<b>Committee:</b>	<b>Date:</b>
Planning and Transportation	2 May 2017
<b>Subject:</b> Bernard Morgan House 43 Golden Lane London EC1Y 0RS Demolition of existing building, retention of existing basement and construction of new residential building to provide 99 dwellings, together with ancillary car parking, hard and soft landscaping and associated works (Total Floorspace 11,113 sq.m. GIA).	<b>Public</b>
<b>Ward:</b> Cripplegate	<b>For Decision</b>
<b>Registered No:</b> 16/00590/FULL	<b>Registered on:</b> 5 July 2016
<b>Conservation Area:</b>	<b>Listed Building:</b> NO

### Summary

# LOSS OF AMENITY

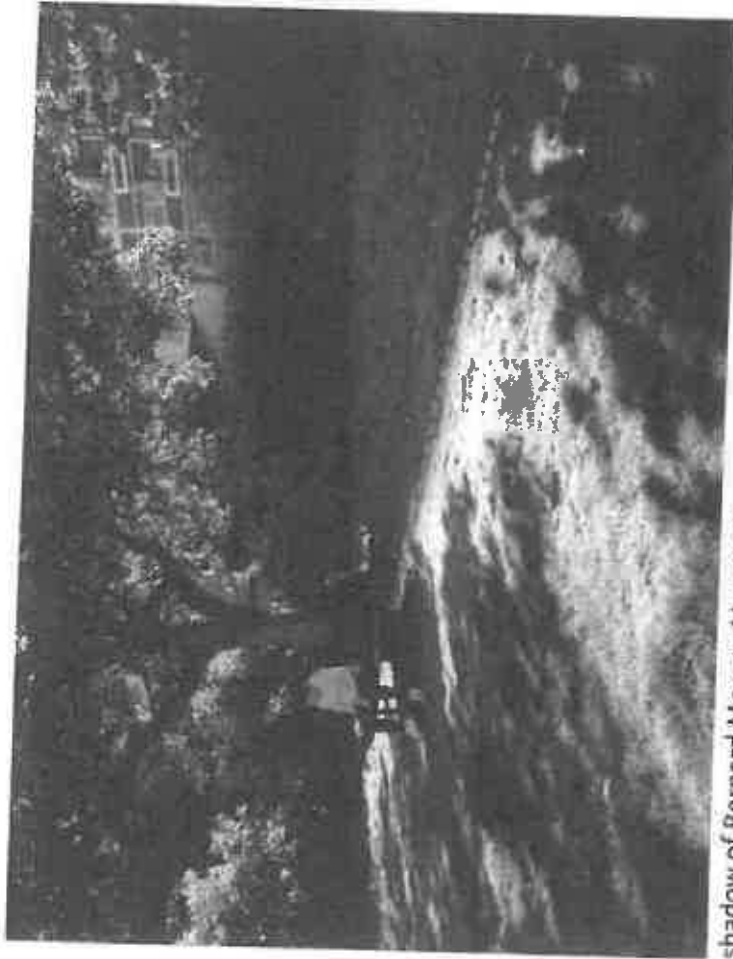
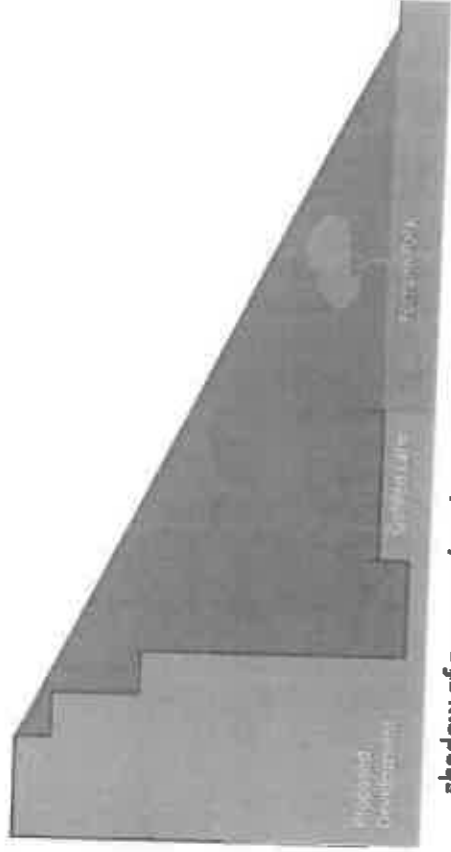
Diminishing quality of Fortune Park through loss of direct lighting

shadow of Bernard Morgan House on 30th of September 2015 at 3:35pm

shadow of proposed replacement at the same time

**Planning Application 16/00590/FULL, 43 Golden Lane, EC1Y 0RS.**

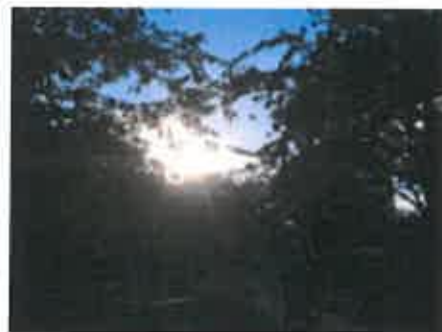
This is the view of the sun clipping the top of Bernard Morgan House on 24th February 2016 at 11:02am. If the block is any higher it will block the sun into our Bowater House apartments.
